CITY PLANNING COMMISSION

APPLICATION:

- A. Negative Declaration
- B. Plan Review of two warehouse/office buildings totaling 17,325 square feet on a portion of 8.6+ vacant acres in the Light Industrial-Review M-1(S)R Zone.

LOCATION: Southwest Corner Raley Boulevard and Vinci Avenue

**BUILDING "B"
 FLOOR PLAN
 ELEVATIONS
 TYPICAL CROSS SECTION**

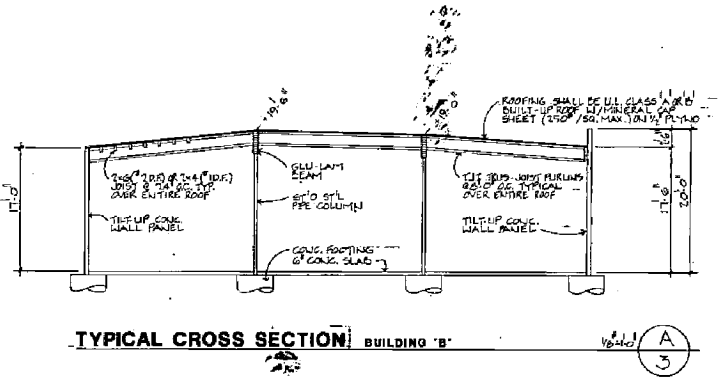
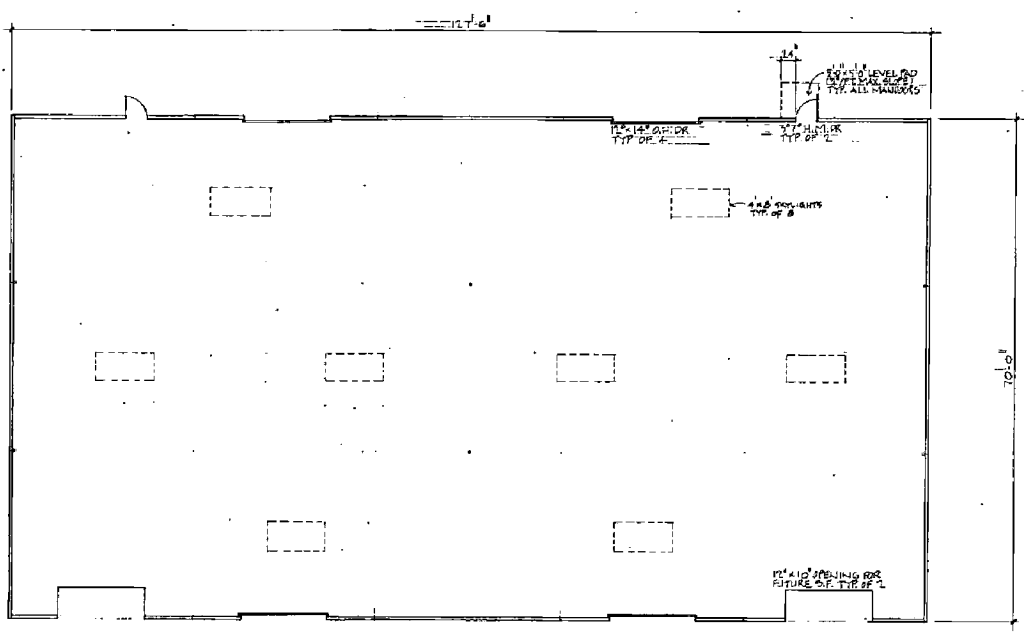
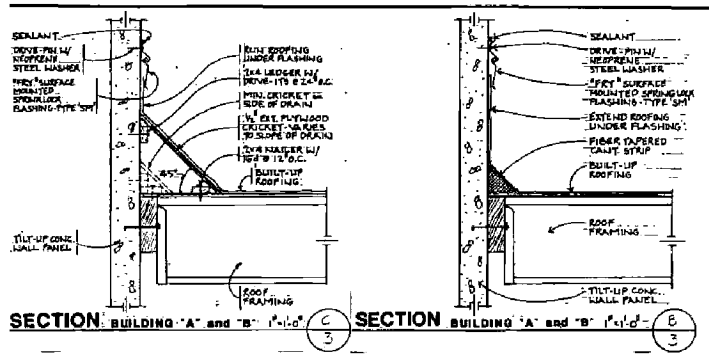
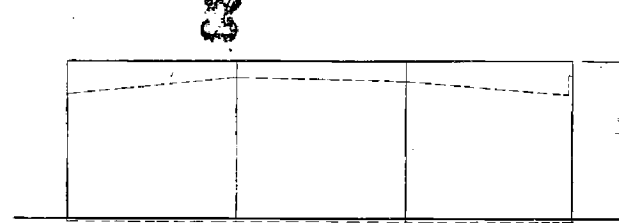
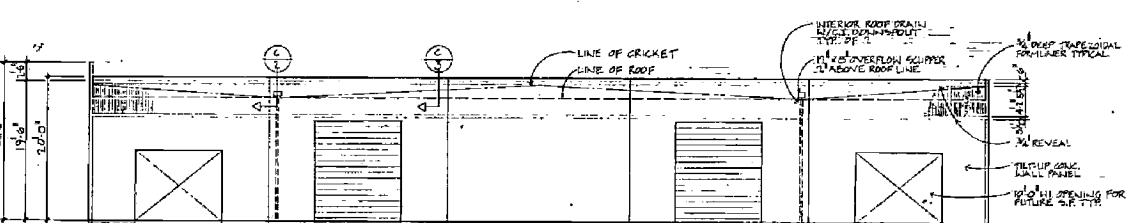
The proposed buildings have loading doors facing Raley Boulevard. Staff does not support the establishment of loading doors facing Raley Boulevard due to unsightliness of metal roll up doors and truck activities facing a major street. On three prior plan reviews, staff recommended, and the Commission approved, buildings with no loading doors facing a major street: Sacramento Security Park (P85-397), approved October 24, 1985, by the Commission; I-80 Industrial Park (P88-057), approved February 25, 1988, by the Commission; and Raley Industrial Park (P89-120), approved May 25, 1989, by the Commission.

Staff recommends the buildings that have the Raley Boulevard loading doors should be eliminated and replaced with a storefront window system or similar decorative treatment for both buildings.

The applicant could also re-orient the buildings on the pads to have loading doors face north and south and incorporate wing walls to screen the loading doors closest to Raley Boulevard.

In discussions with the applicant, the exterior elevations will have the formliner extended to the Vinci Avenue frontage elevations. Staff has recommended the addition of one or two reveal lines to be painted a contrasting color to accent the building on all four elevations. Final elevations shall be reviewed and approved by the City Planning Director and Design Review Coordinator.

2. The applicant shall revise the exterior elevations to the satisfaction of the City's Design Review Coordinator and Planning Director. All proposed colors are to be included in the revised elevations.

IRRIGATION PLAN

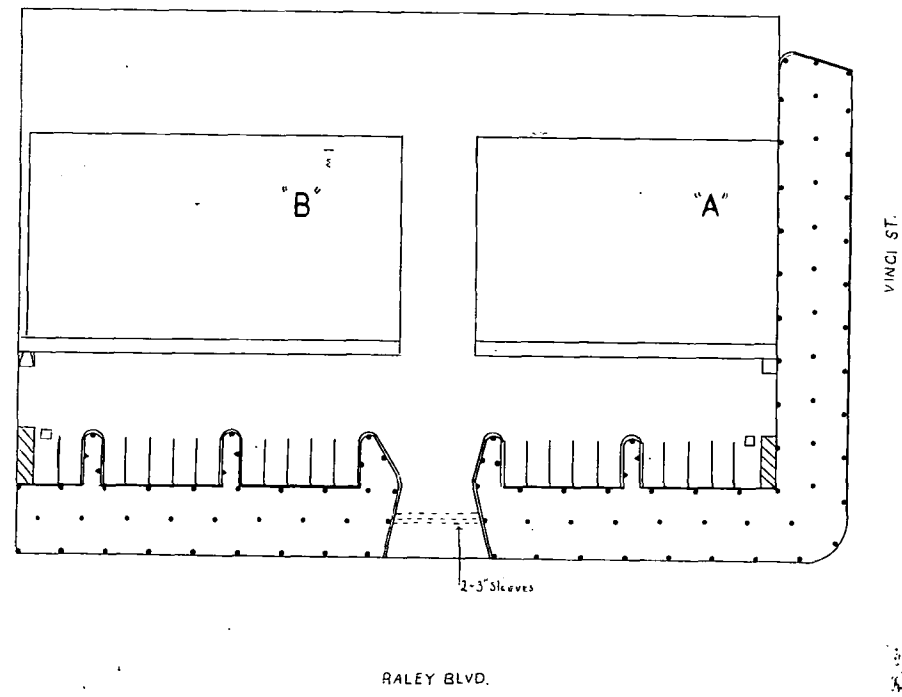
Staff recommends detailed landscaping and irrigation plans be reviewed and approved by the Planning Director prior to issuance of building permits. The applicant is required to comply with the requirements of the City Tree Shading Ordinance for parking and maneuvering areas so that final placement of trees and shrubbery will require further review. Ground cover in the 25 foot landscape setback shall be lawn. No bark mulch will be allowed as shown on the landscape plan in the 25 foot landscape setback area.

LANDSCAPE PLAN

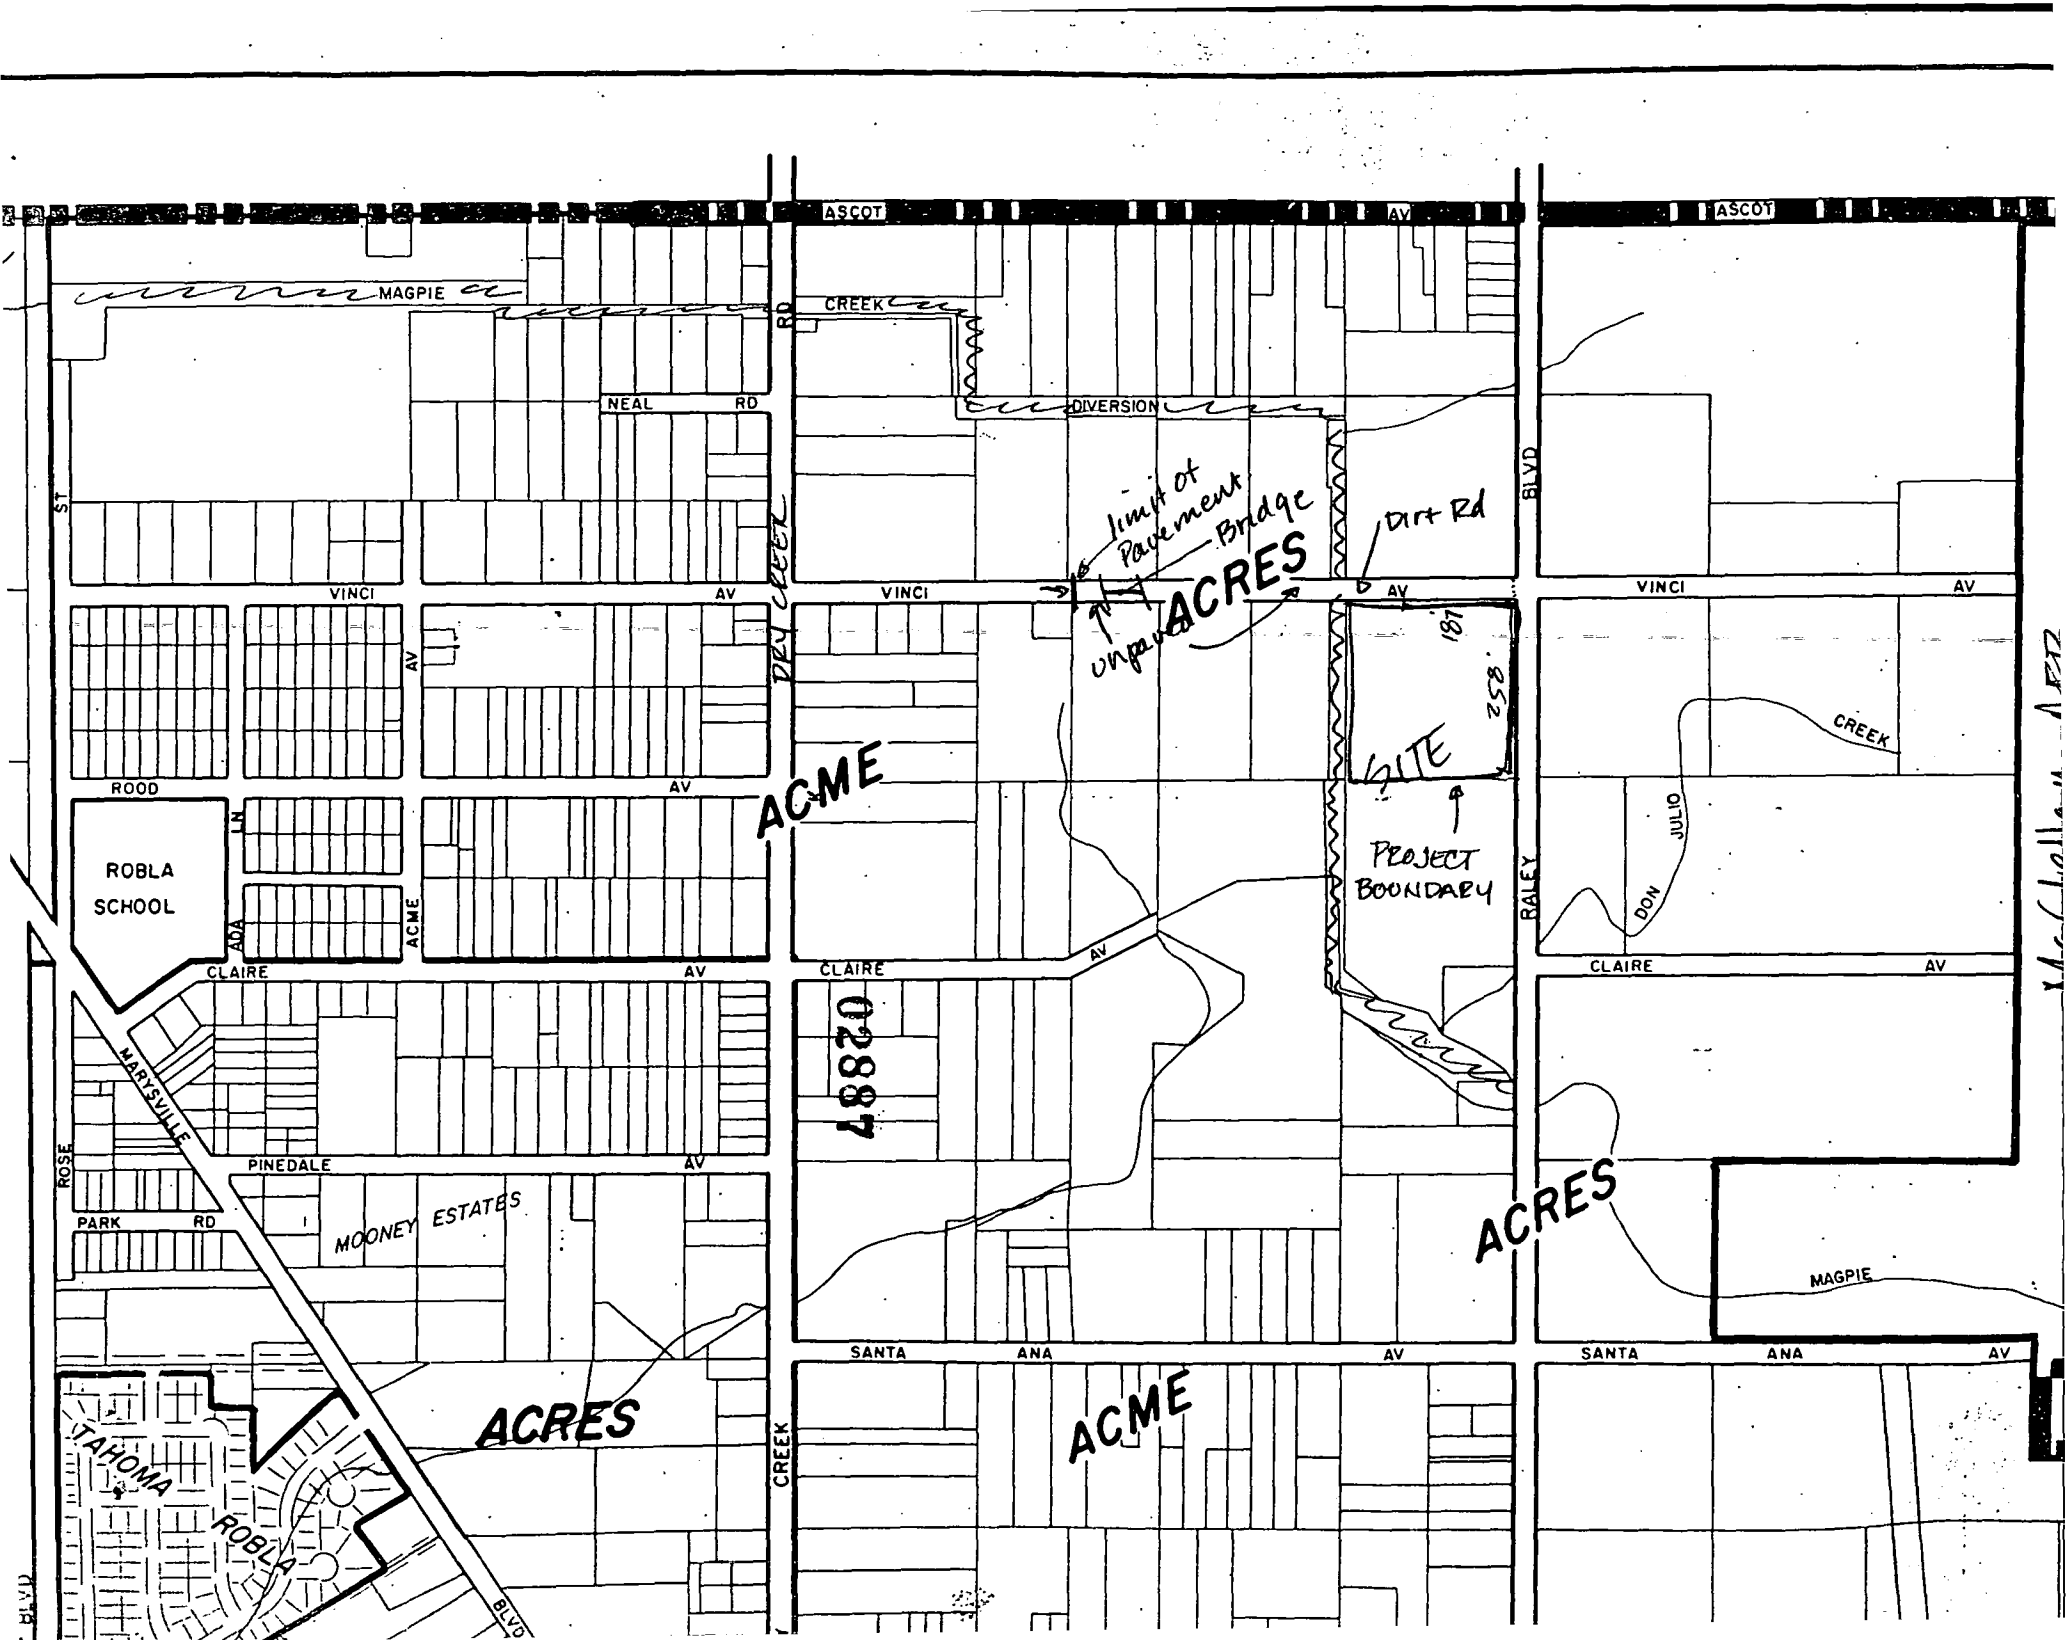
Adequate setbacks are being provided from street rights-of-way and proposed property lines. A 25 foot landscape setback is shown along Raley Boulevard and Vinci Avenue. Similar to past Commission actions on U.S. Machinery (P86-160), staff recommends a 3 1/2 foot high continuous berm planted with a mix of evergreen and deciduous trees along the street frontages at a density of one tree per 30 feet of lineal frontage. Trees are to be a mix of 5 and 15 gallon specimen size.

Staff notes an absence of planting area adjacent to the buildings. On previous requests, staff has recommended narrow planters with vines planted adjacent to the building or tree wells to provide breaks in the place of the wall's blank facade. The landscape plan should show plantings adjacent to the buildings.

1. The applicant shall prepare a revised site plan, detailed landscaping and irrigation plans for review and approval by the Planning Director prior to issuance of building permits. Plans shall reflect the treatments discussed in this report.
